Petition Number: 2023-017 General Location Identifier: 22319125

Date	Description		
06-28-23	First Review (PDM)		
10-25-23	Second Review (JP)

General Review Information

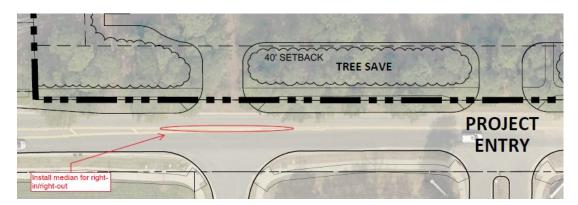
1. Curbline:

a. **Providence Road West:** Location of curb and gutter future back of curb to be installed 19 feet from roadway centerline of the roadway to accommodate a 2+lane street typical section.

Label and dimension the curb and gutter from the centerline for each road on the site plan.

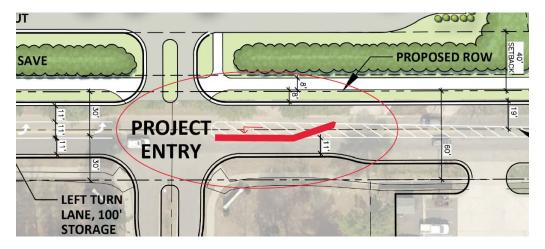
- 13. New Comment 10.25.2023 Revise proposed intersection improvements to construct matching short westbound left turn lane at location of full access driveway and newly constructed eastbound left turn lane.
